Addendum 05

PROJECT: Fort Loramie Local Schools Athletic Complex Building & Associated Improvements
600 East Park Street
Fort Loramie, Ohio 45845

PROJECT #: 25041.00

This addendum form is a part of the Contract Documents and modifies the Bidding Documents dated December 11, 2025 with amendments and additions noted below.

SHEET NUMBER:
M5.1

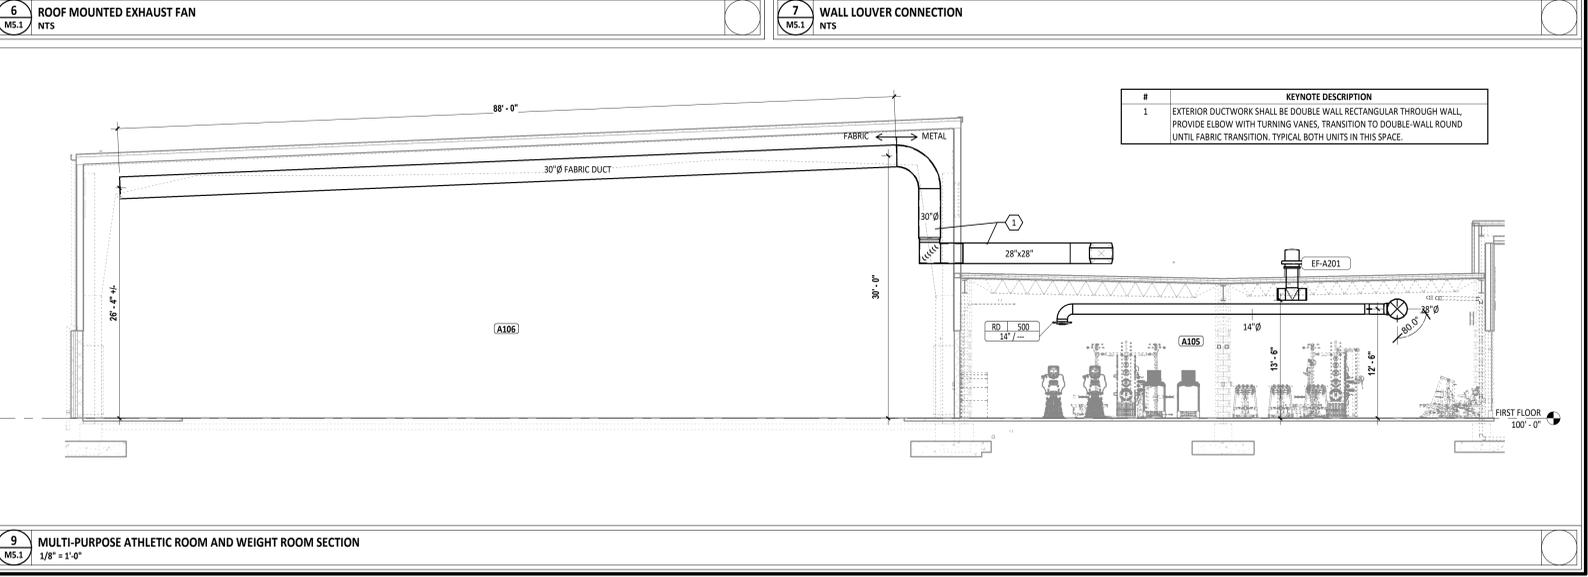
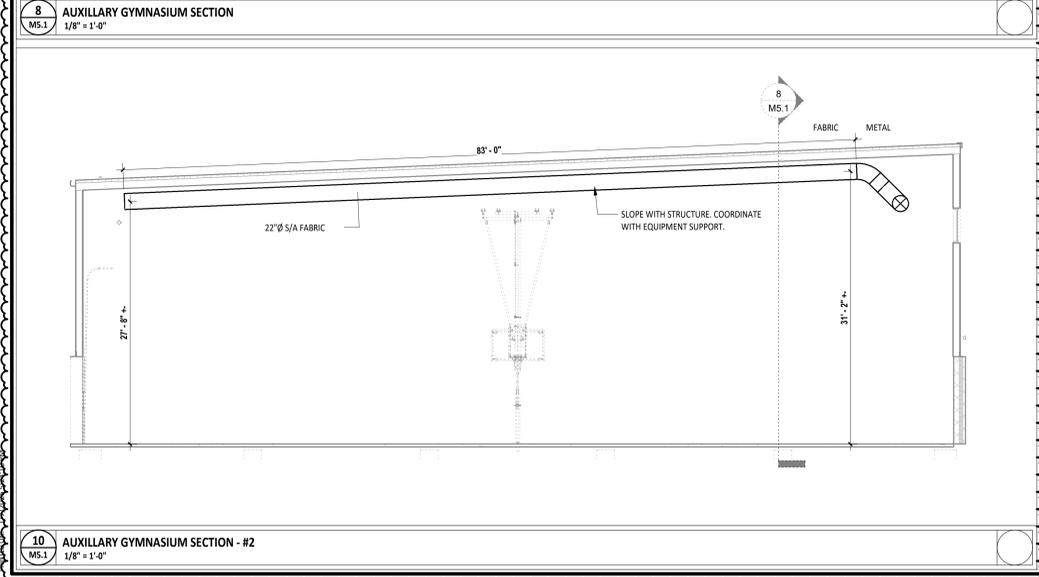
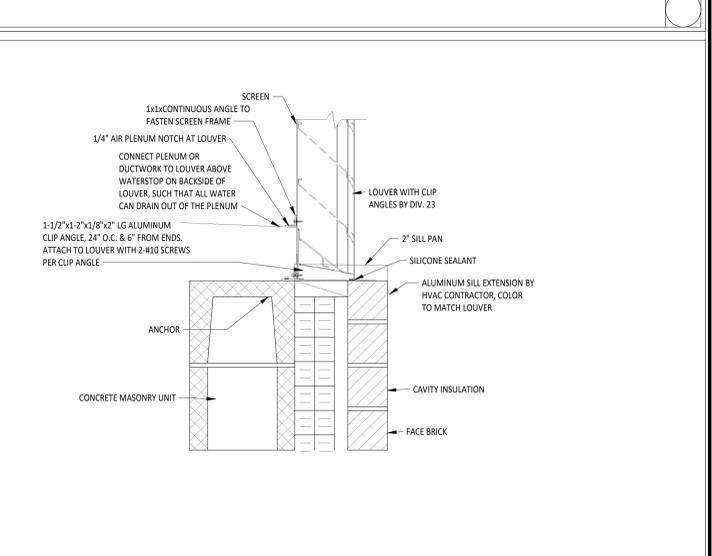
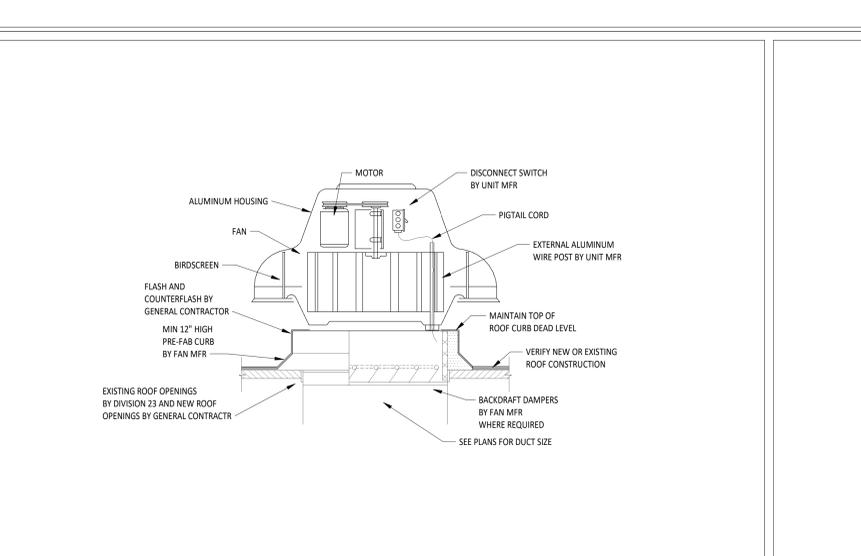
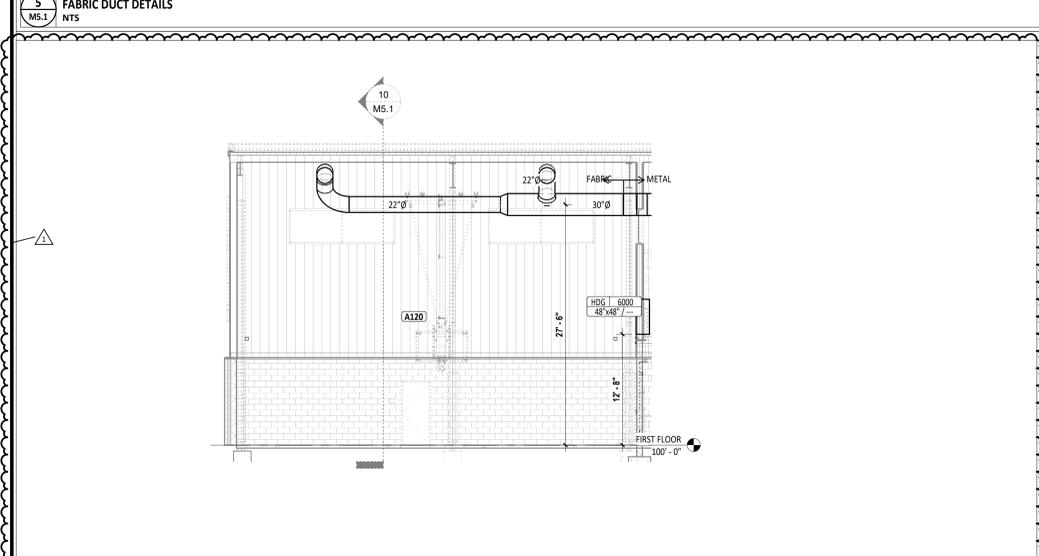
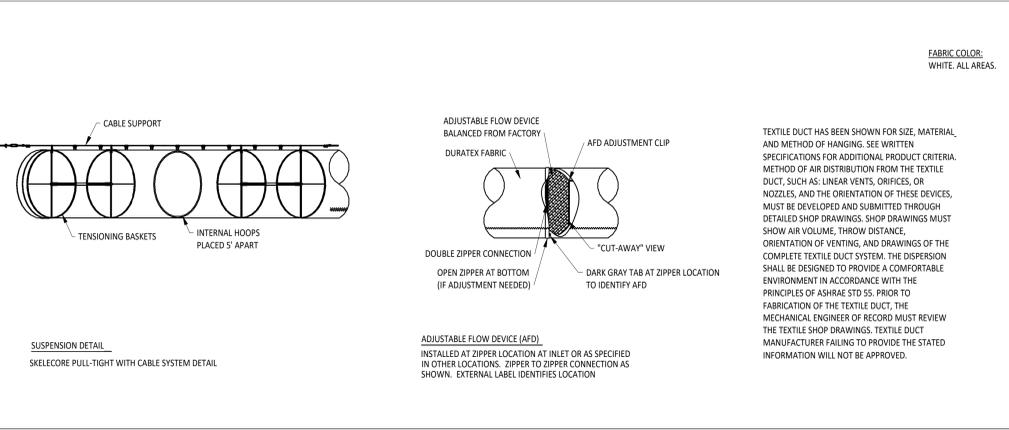
12. Sheet M5.1 – Mechanical Details
 - a. Update detail 2/M5.1.
 - b. Update section view 8/M5.1.
 - c. Add new section view 10/M5.1.
13. Sheet E1.2 – Electrical Details

SHEET NUMBER:
E2.1

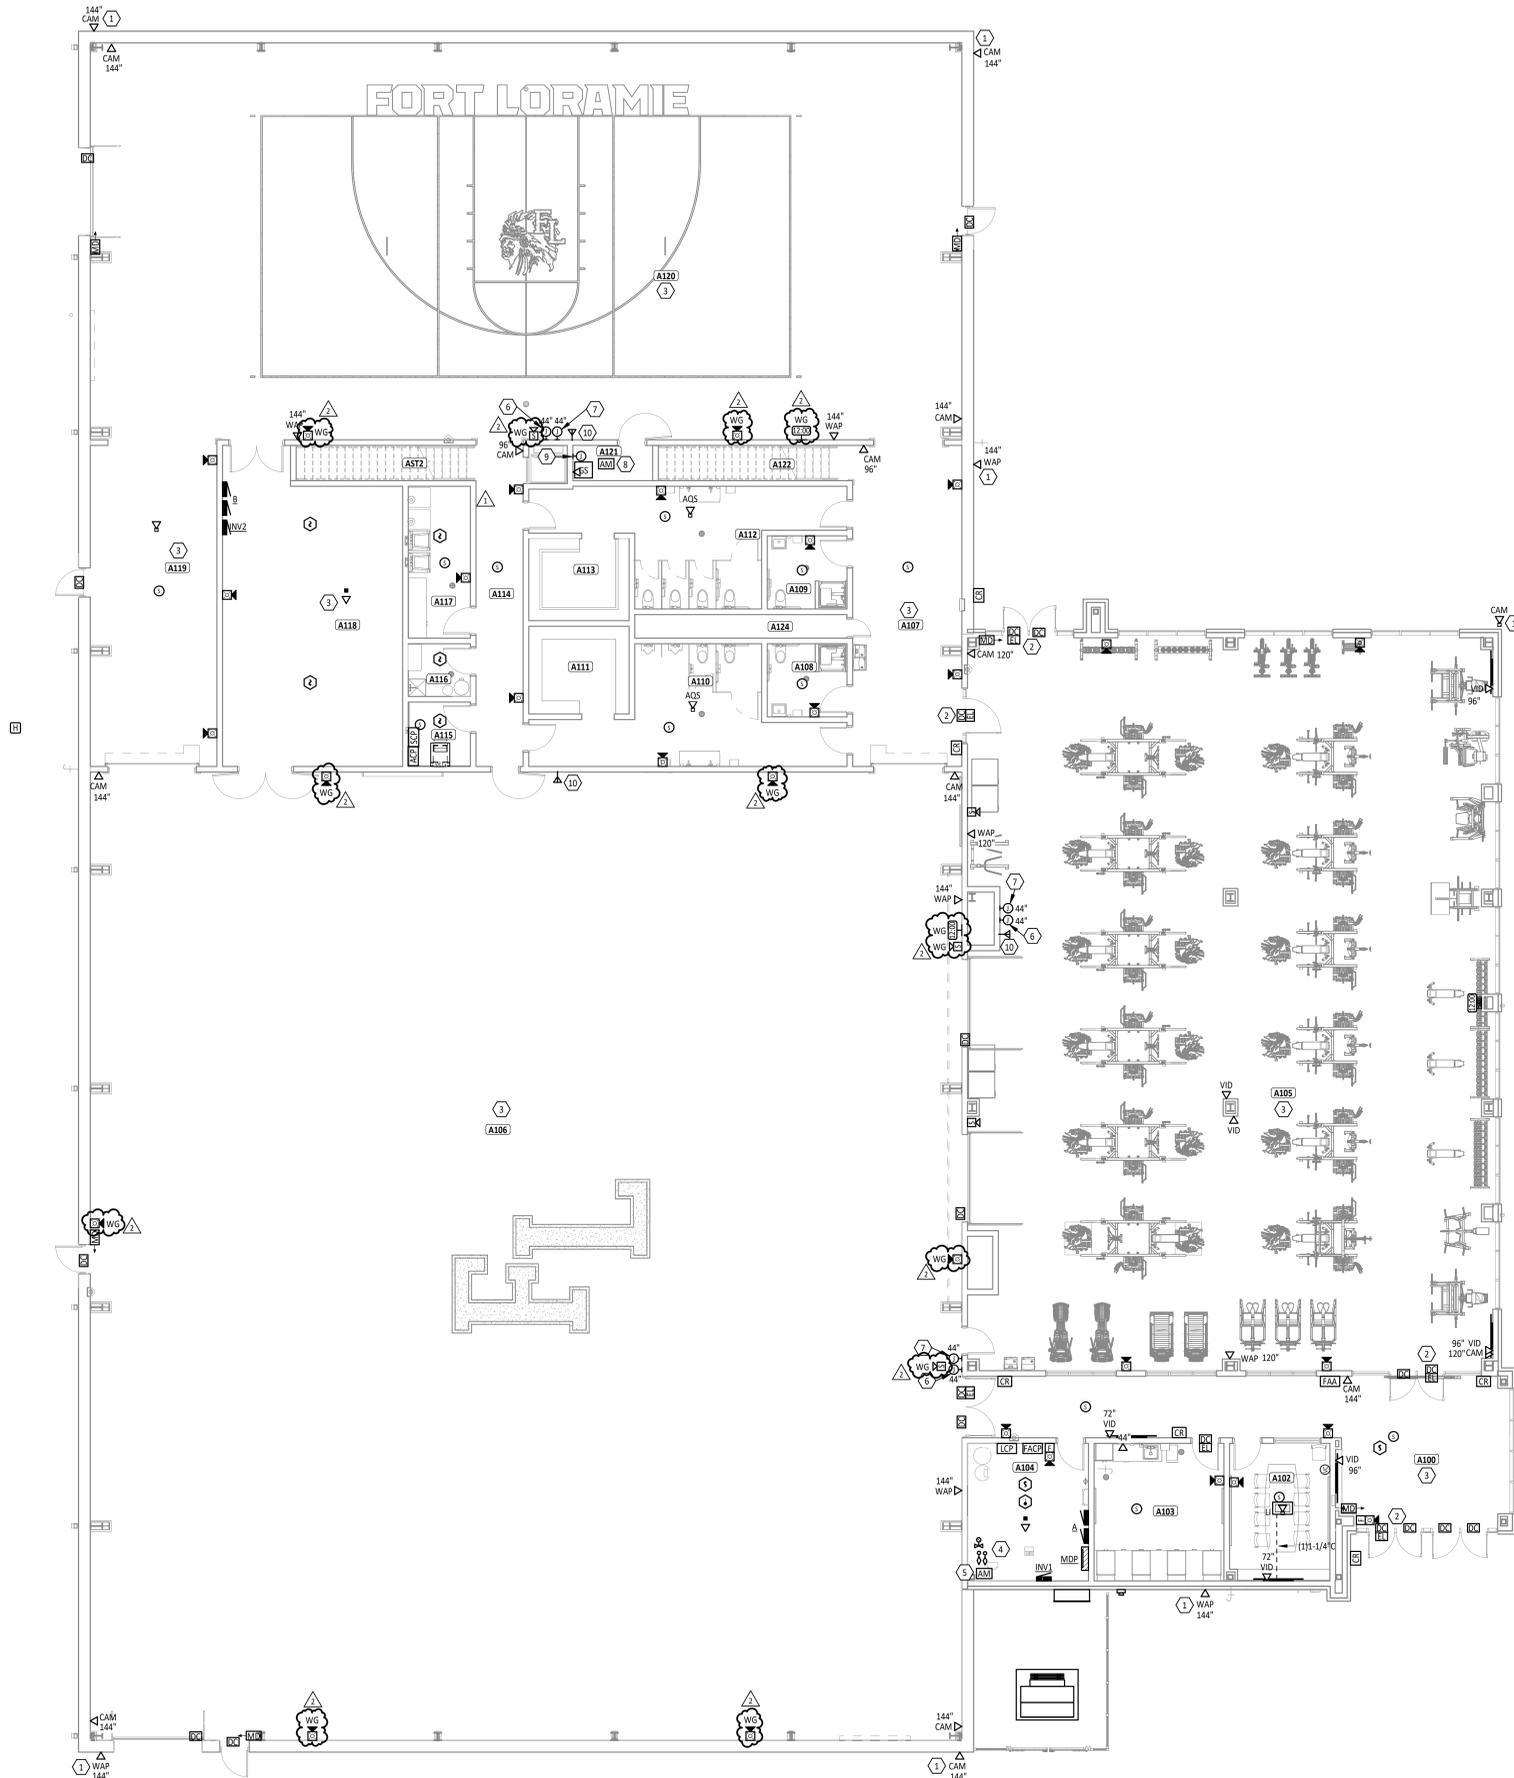
- d. Removed access control system schematic wire diagram (already on T series sheet).
14. Sheet E2.1 – Site Electrical Plan
 - a. Keynote 11 – Adjusted grounding size to technology room.

SHEET NUMBER:
E3.1

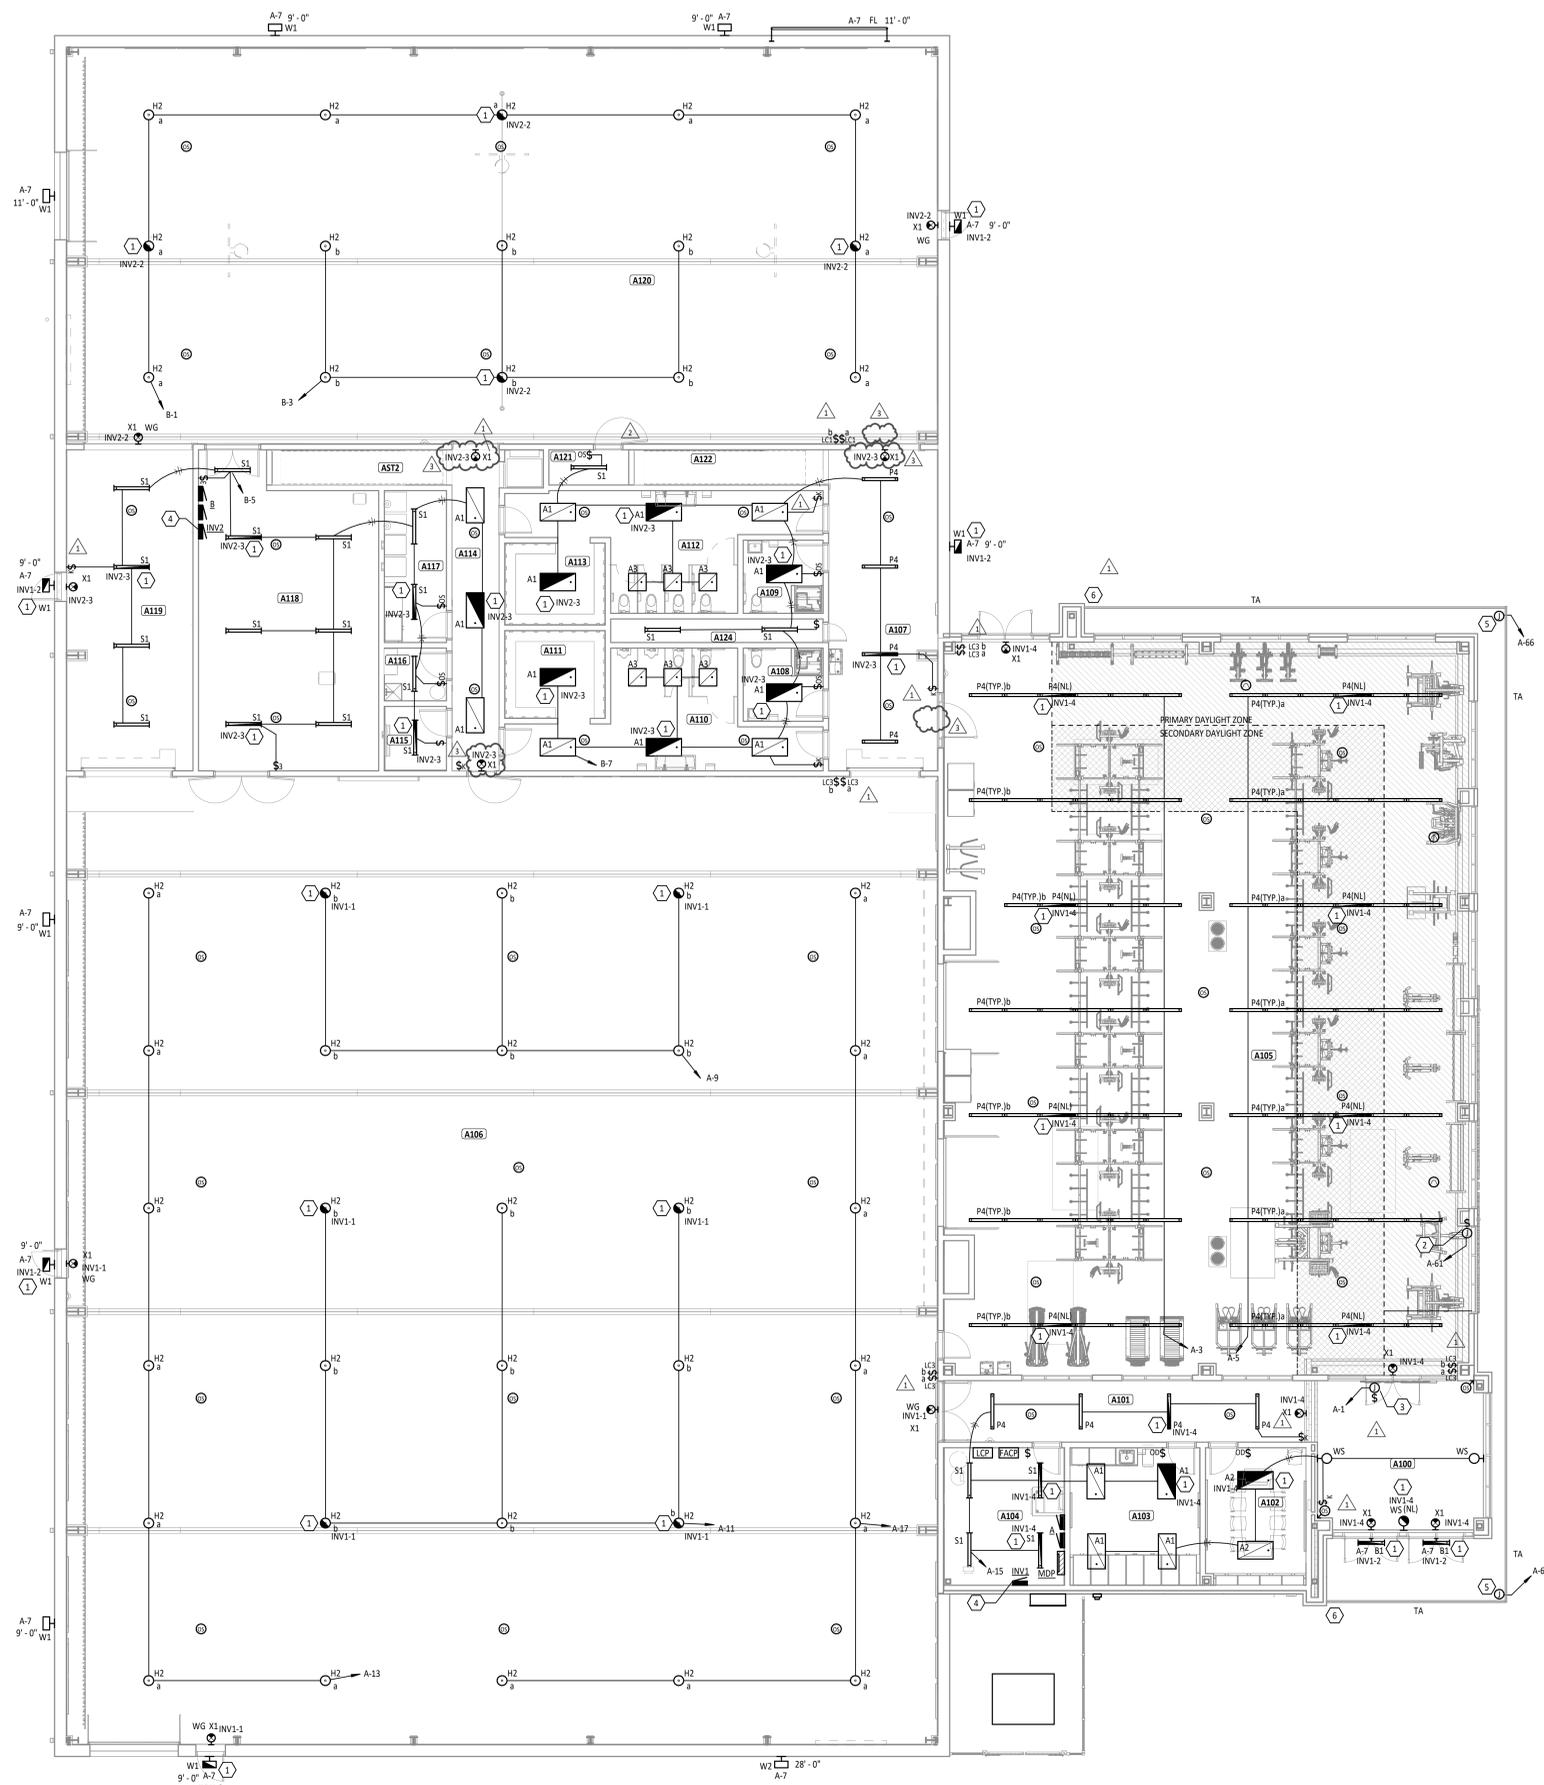
15. Sheet E3.1 – First Floor Systems Plan
 - a. Provided wire guard for fire alarm devices, clocks, and speakers in A106.
 - b. Provided wire guard for fire alarm devices, clocks, and speakers in A120.
